COA (SP) 2017-006  
June 15, 2017

**STAFF REPORT  
SPECIAL CERTIFICATE OF APPROPRIATENESS  
FOR THE PROPERTY AT  
711 UNIVERSITY DRIVE  
A LOCAL HISTORIC LANDMARK**

**Proposal:** The application requests design approval for additions and alterations to the residence and sitework.

**Figures 1: Main Entry, 2017 - Original door behind security door [left]  
Existing casement window behind iron grille [right]**

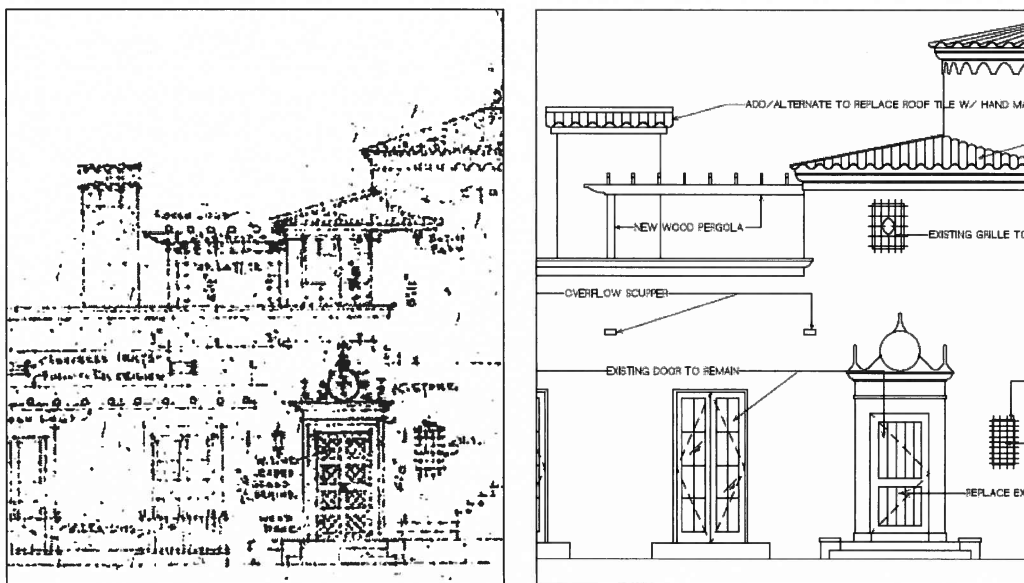
**Sheet A3.0** On the primary (south) façade facing University Drive, the existing front door and two pairs of French doors leading into the living room are to remain and be restored. The proposed elevation notes to “replace existing hurricane screen door” although it is unclear what this note means.

The existing screen door is a non-original iron and screen security door, not hurricane protection (see Figures 1 left). The two original wrought iron picket railings for the balconettes are proposed to be removed. The existing iron grilles found on this façade are to remain. Two windows – one on the second floor window within the tower and one behind the iron grille on the first floor will be replaced with fixed windows. The existing tower window is believed to be a stained glass window although it is drawn without muntins. The first floor window is not depicted, but should have a single horizontal muntin to match what the existing window (see Figures 1 right).

**Figure 3: Existing Side Door**

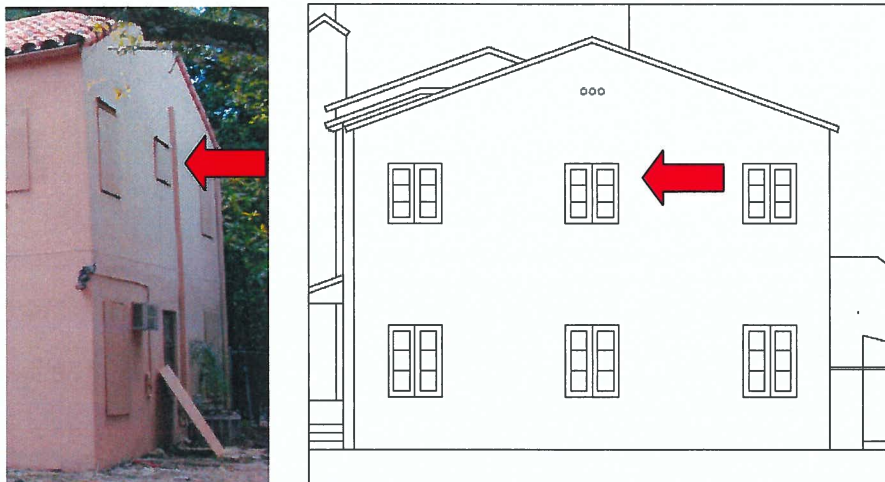
**Sheet A3.1** At the east façade facing Palmarito Street, the existing doors and windows will be replaced with impact-resistant units that match the existing original windows. The existing side door is proposed to be removed. Note that the side door in the existing elevation does not depict what is actually on site. The existing door is obscured behind steel and screen security door and Staff is not able to verify if it is original to the residence at this time. The existing awnings is to be removed and a new wood canopy clad with two-piece barrel tile is proposed to provide protection for the door. Details were not provided for the canopy. The existing steps are to be replaced, but the material for the new steps was not provided. To the north, the existing garage doors (not original) will be replaced with new roll-up garage doors that are intended to give the appearance of carriage doors.

- All overflow scuppers are to be copper per the BOA recommendation.
- If Staff determines that the side door facing Palmarito Street is original, it is to remain.

**Figures 4: North elevation windows – 2016 photograph [left]; existing elevation [right]**

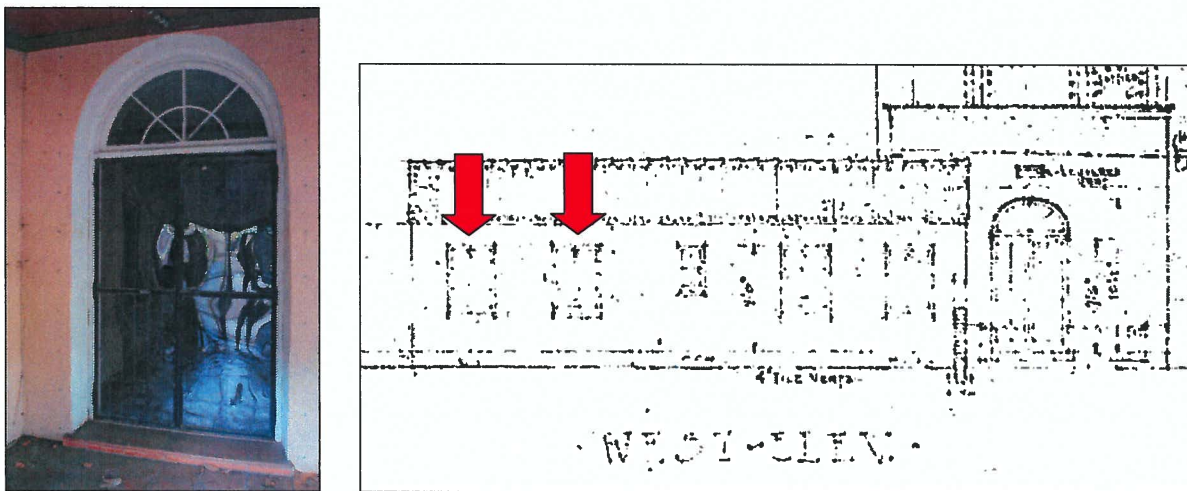
**Sheet A3.2** On the north elevation, the windows are to be replaced with the exception of the middle first floor window which will be enlarged and converted into a pair of French doors. Note that the middle second floor window is not depicted correctly on the existing elevation drawings and is smaller than the two flanking windows (see Figures 4). The proposed trellis spans two-thirds of this elevation over three round concrete columns. The one-story addition on the west elevation is visible behind a new 5'-0" wall with an iron picket gate. On the east side of this elevation, the new gate (similar the west side, but smaller) proposed for the perimeter wall is visible beyond.

**Figure 6: East elevation windows – listing photograph [left]; proposed elevation [right]**

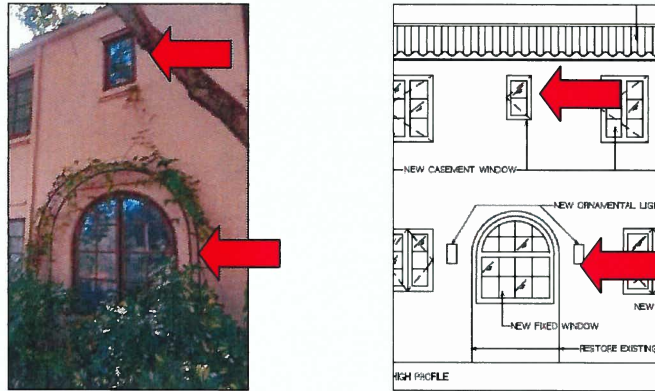
- Because the existing window openings of the residence are boarded up, Staff cannot verify that each of the windows shown on the existing and proposed elevations is correct. Discrepancies were noted between the listing photographs and the drawings (see Figure 6 for example). The existing window openings are to remain unchanged throughout (unless noted) and Staff wants the opportunity to verify that the existing windows are being matched.
